STRUCTURAL EVALUATION OF
RICHMOND HIGH SCHOOL
WEST CONTRA COSTA UNIFIED SCHOOL DISTRICT
(WCCUSD)

WLC Architects
Kaiser Building
1300 Potrero Avenue
Richmond, CA 94804

DASSE Design, Inc.
33 New Montgomery Street #850
San Francisco, CA 94105
(415) 243-8400

October 17, 2002

Drawing 12: Classroom Building 400 (Unit D), Roof Framing Plan

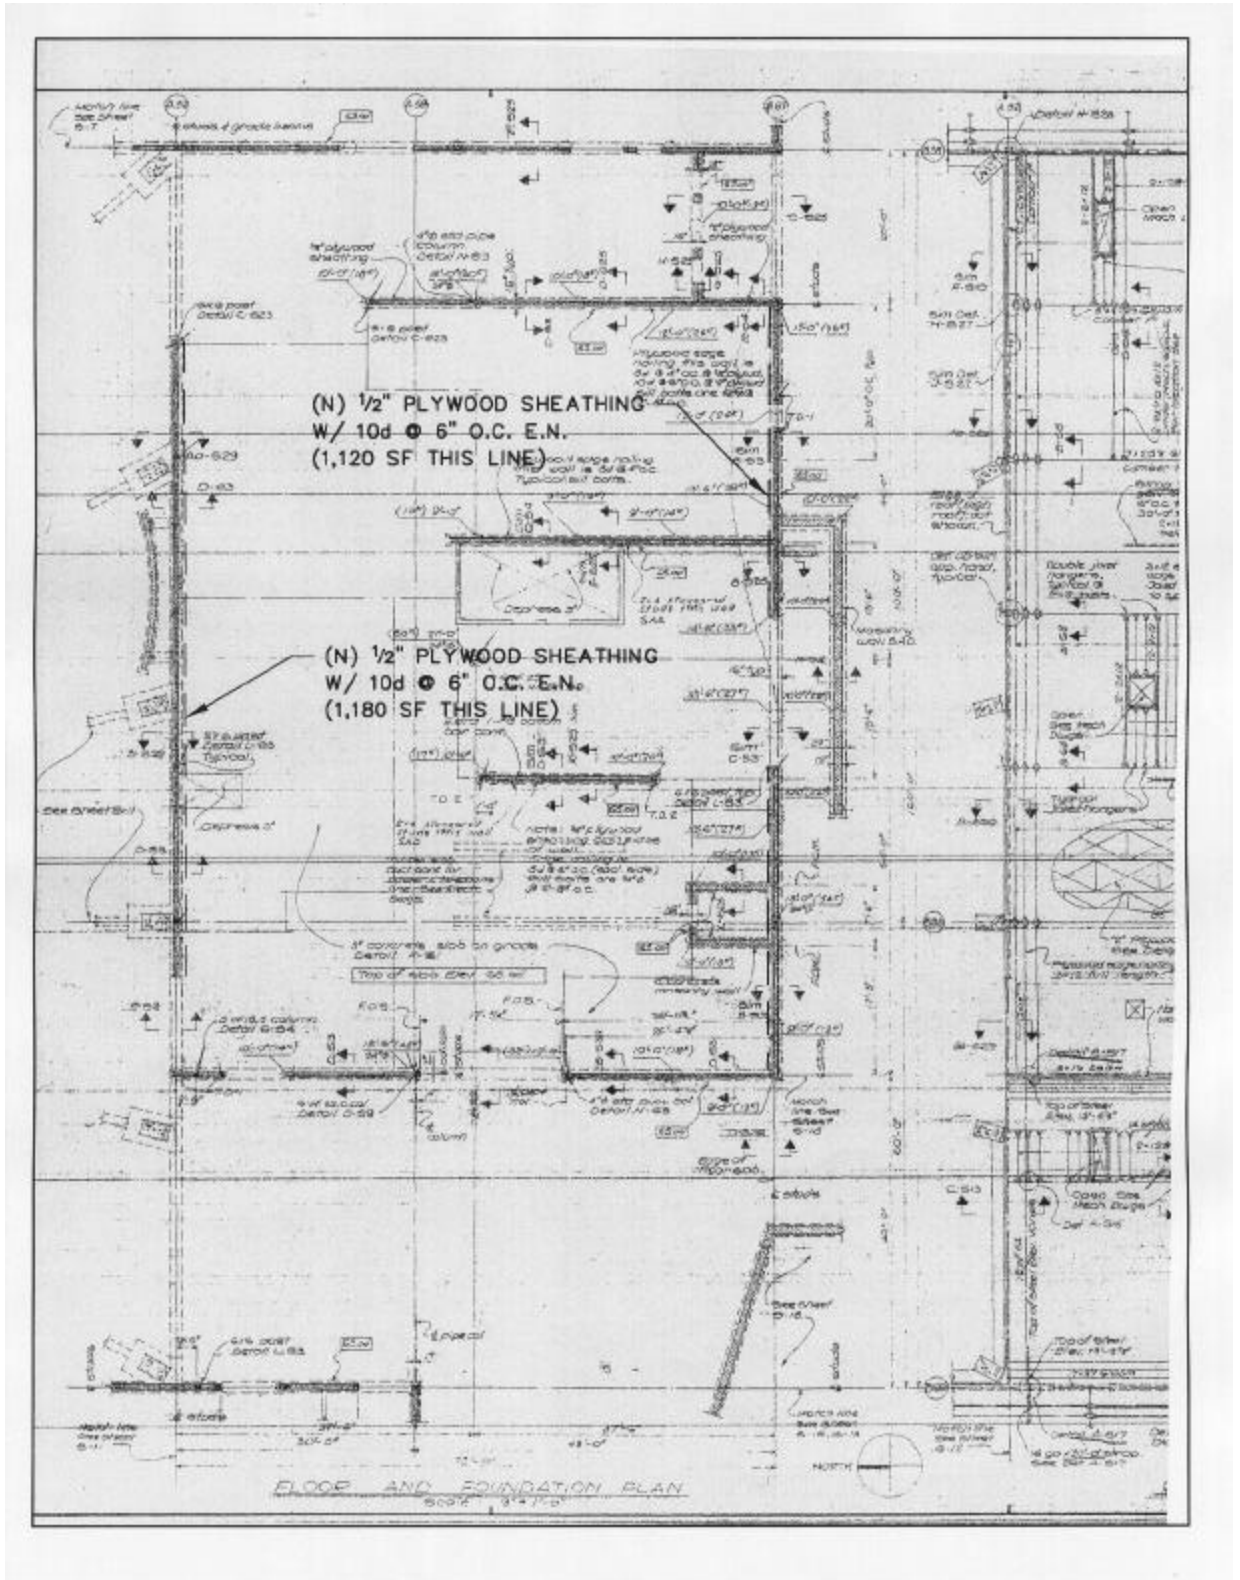
13.	Unit D, 300: Wood collector connections lack adequate strength to resist the expected seismic forces at critical locations.
14.	Unit D, 400: Plywood sheathed diaphragm lacks continuity and adequate shear strength to resist the expected seismic forces.

15.	Unit D, 400: Concrete moment frames lack adequate ductility and strength required to resist the expected seismic forces.
16.	Unit D, 400: Concrete collector beams lack adequate strength and lateral bracing to resist the expected seismic forces.

13.	Provide new metal strapping at critical locations.	1.5	10
14.	Provide new plywood sheathing over existing attached with staples. Provide new framing members at new panel edges as required.	1.1	12

16.	Provide new concrete collector beams at the perimeter lines. Provide new concrete collector beams at interior "ring".	1.3	12
17.	Provide new second layer of plywood sheathing on the backside on the existing wood shear walls with edge nailing to match the existing.	2.0	13

Drawing 13: Classroom Building 500 (Unit D), Foundation Plan

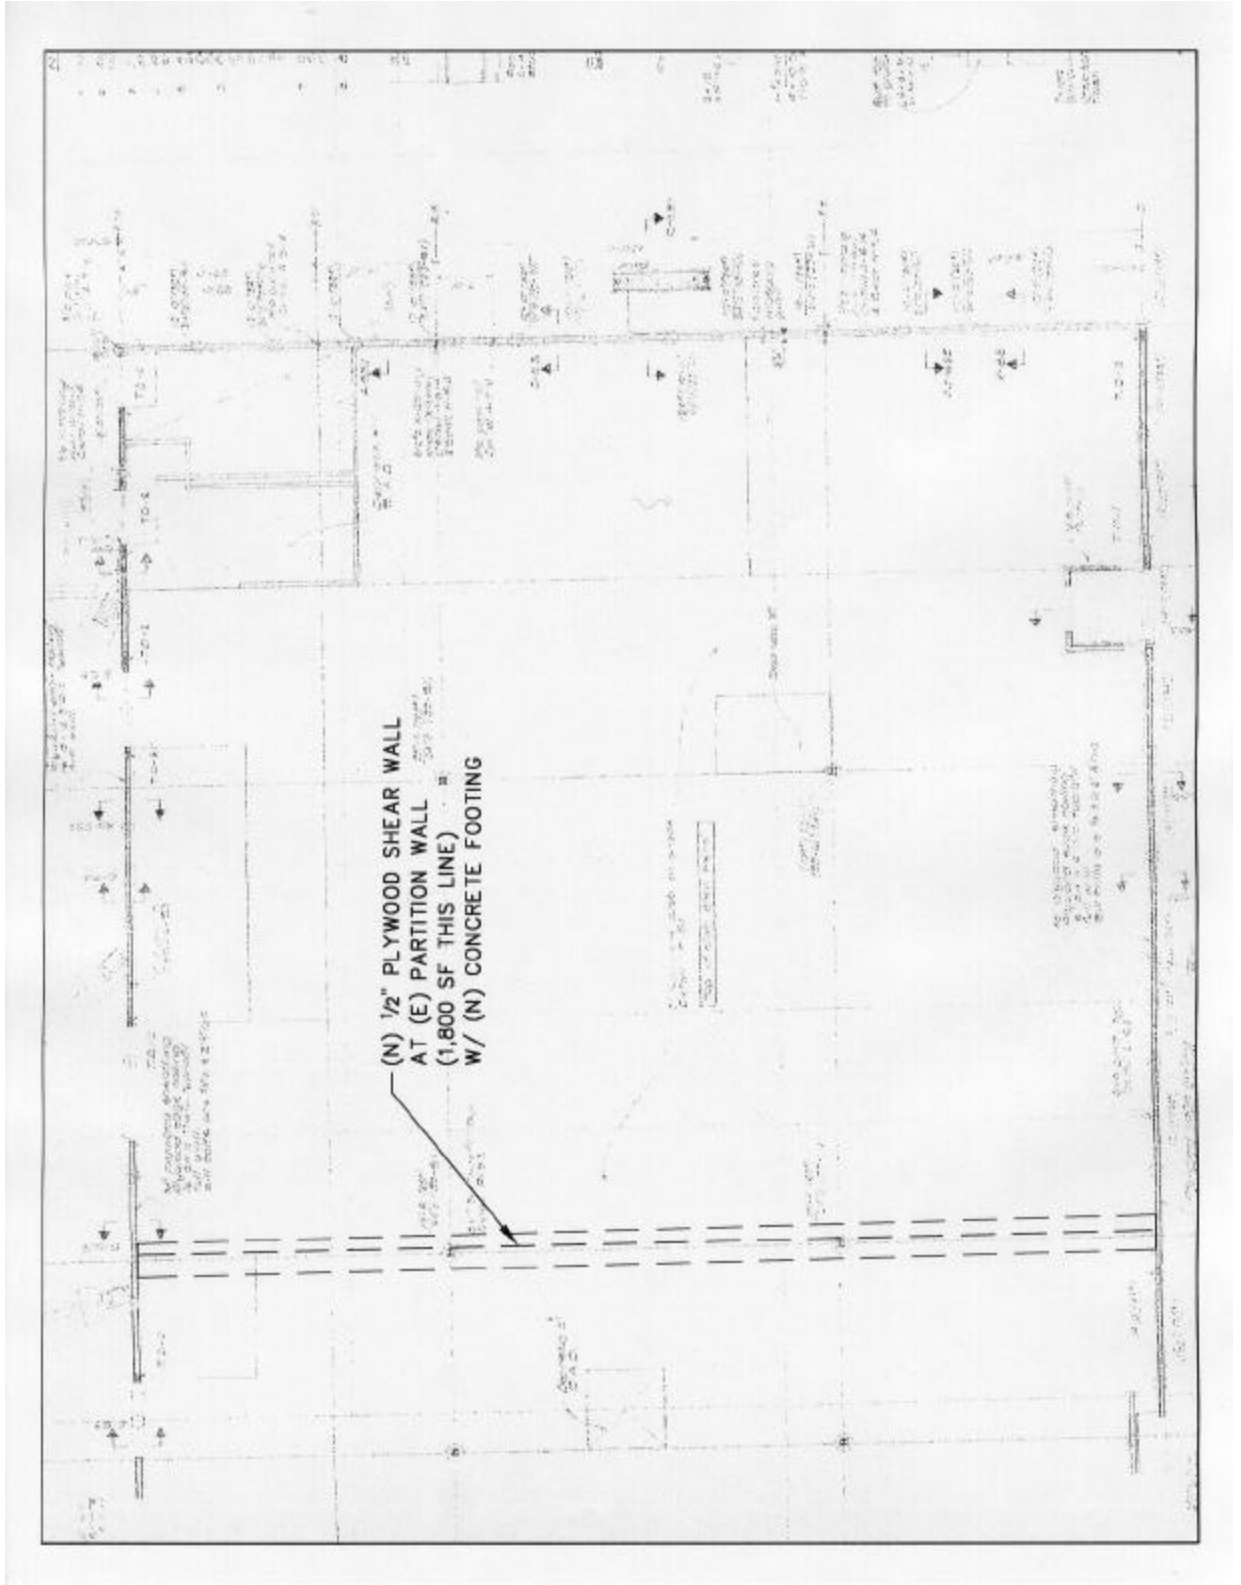
17.	Unit D, 500: Plywood sheathed walls lack adequate shear strength to resist the expected seismic forces.
18.	Unit D, 600/700: Plywood sheathed diaphragm lacks adequate shear strength to resist the expected seismic forces.

Drawing 16: Classroom Building 600 (Unit D), Roof Framing Plan

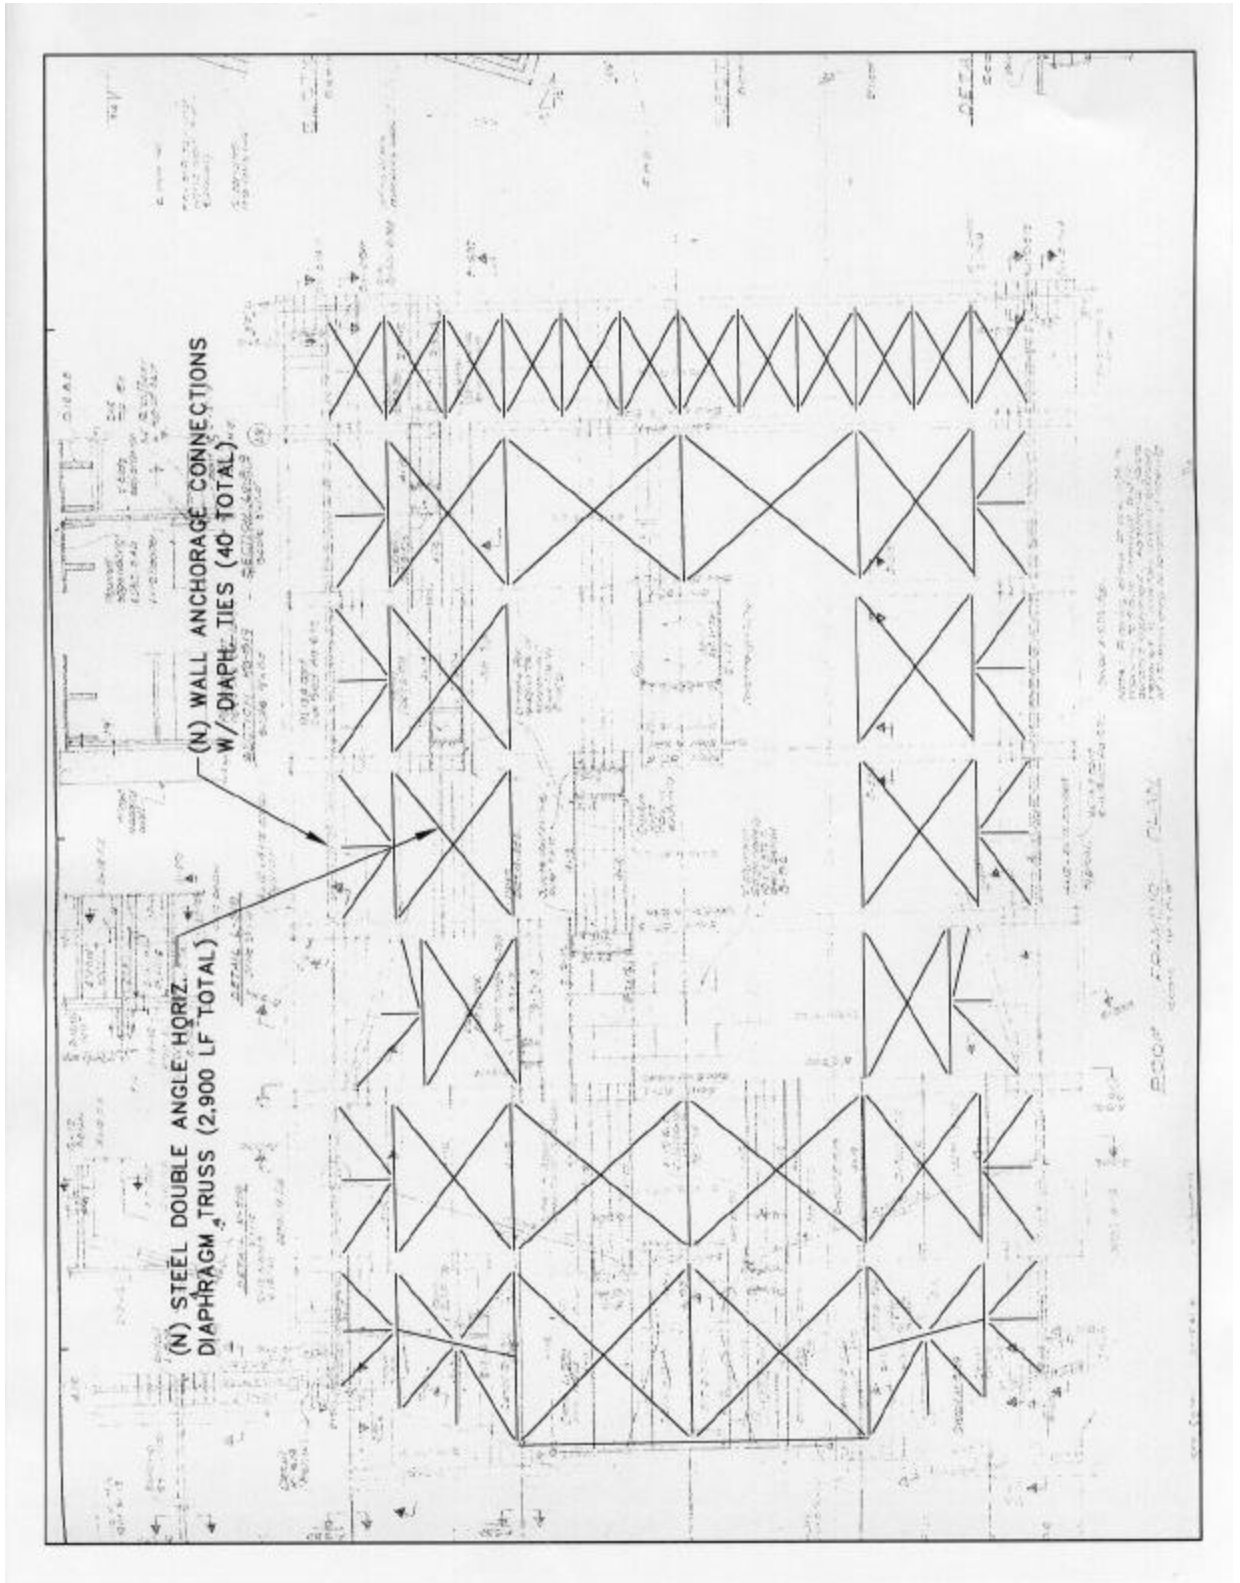
19.	Unit D 600/700: Masonry wall anchorage connection lacks adequate strength to transfer the expected out-of-plane seismic forces.
20.	Unit D, 800: Plywood sheathed diaphragm lacks adequate shear strength to resist

18.	Provide new diaphragm nailing at existing plywood panel edges (longitudinal). Provide new plywood shear walls at existing partition wall locations. Provide new concrete footings (transverse).	2.5	14, 15, 16, 17

19.	Strengthen concrete wall anchorage connection and plywood roof diaphragm with new wall anchors, diaphragm ties, and diaphragm nailing as required.	1.1	16, 17

Drawing 18: Classroom Building 800 (Unit D), Roof Framing Plan

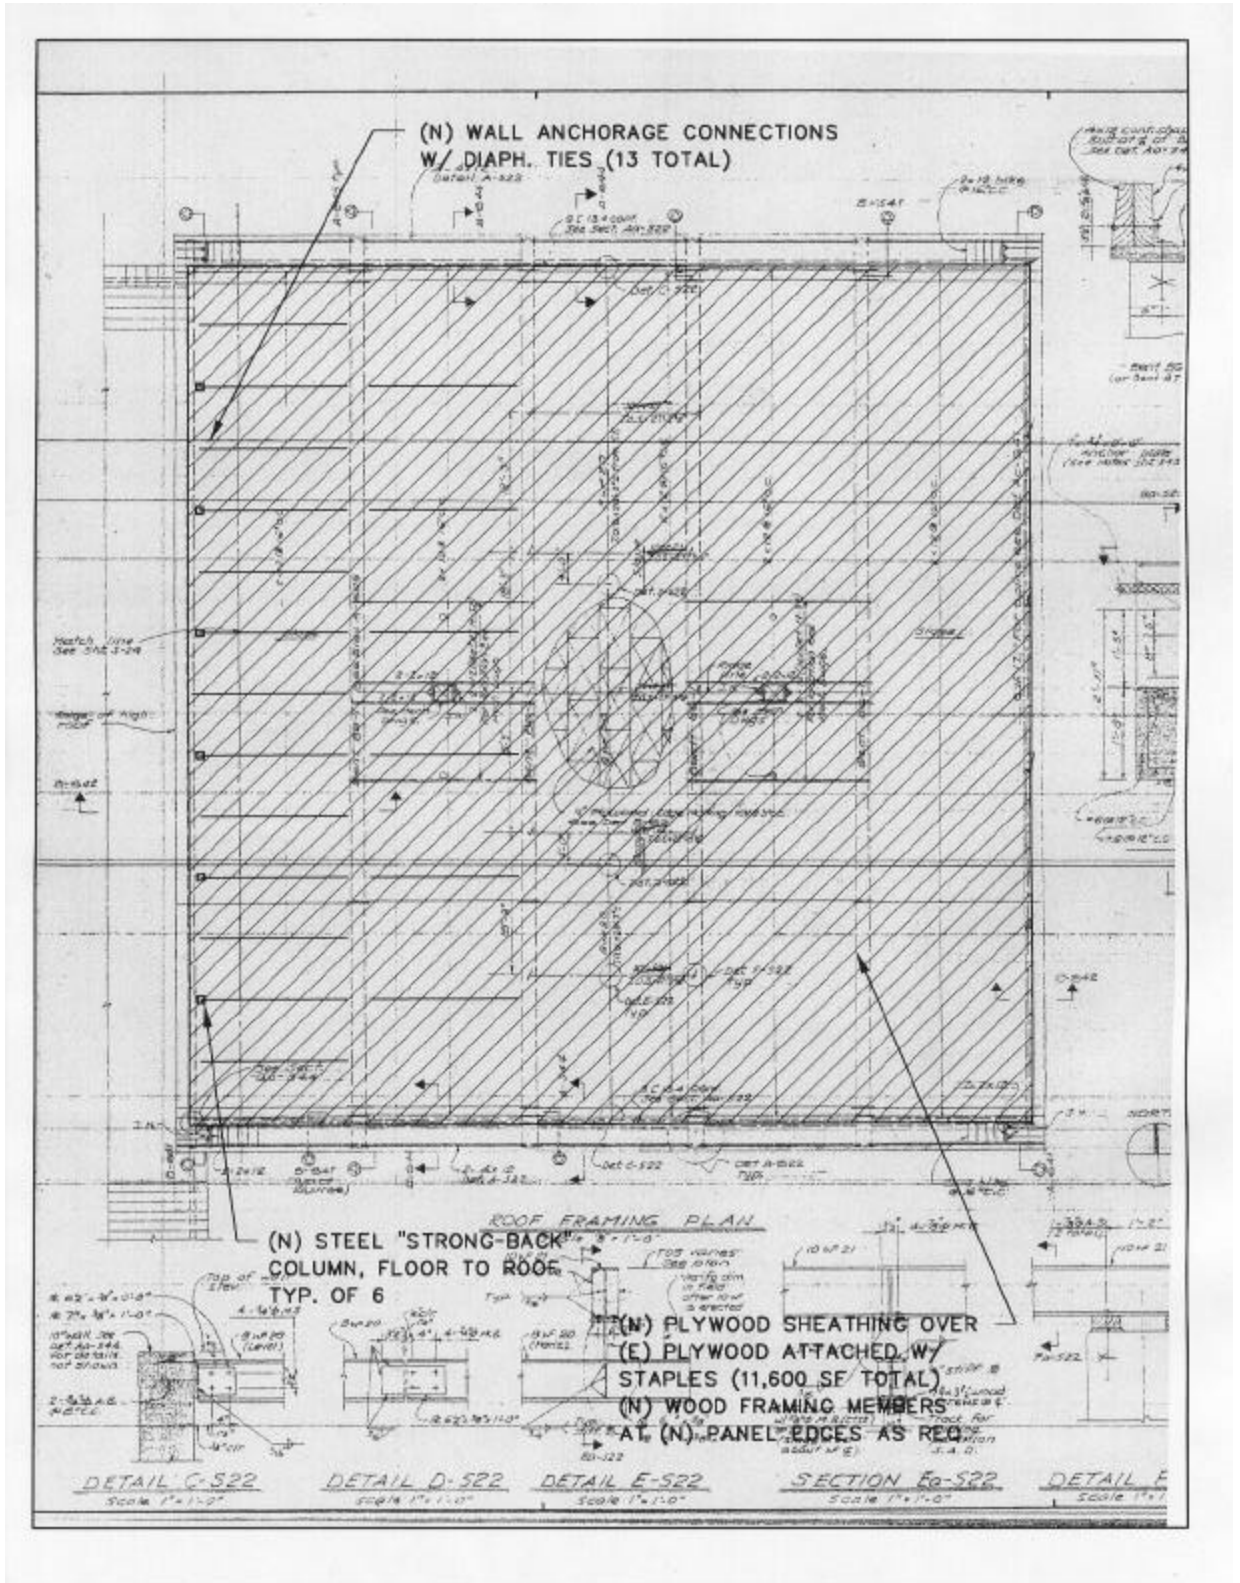
Item	Building Structural Deficiencies
	the expected seismic forces.
21.	Unit D, 800: Masonry wall anchorage connection lacks adequate strength to transfer the expected out-of-plane seismic forces.
22.	Unit D: Hard conduits crossing seismic separation joints lack the ability to withstand differential building displacements.
23.	Unit E, Gym: Plywood sheathed diaphragm lacks adequate shear strength to resist the expected seismic forces.
24.	Unit E, Locker Room: Wood collector connections lack adequate strength to resist the expected seismic forces at critical locations.
25.	Unit E, Gym: Concrete wall anchorage connection lacks adequate strength to transfer the expected out-of-plane seismic forces.
26.	Unit E, Gym: Concrete walls lack adequate flexural strength to resist the expected out-of-plane seismic forces.

20.	Provide new double angle members and connections with anchorage into lateral load resisting members to create a new horizontal diaphragm truss.	1.1	18

21.	Strengthen concrete wall anchorage connection with new wall anchors and diaphragm ties.	1.1	18
22.	Provide new flexible conduit connections across seismic separation joints.	1.9	N.A.
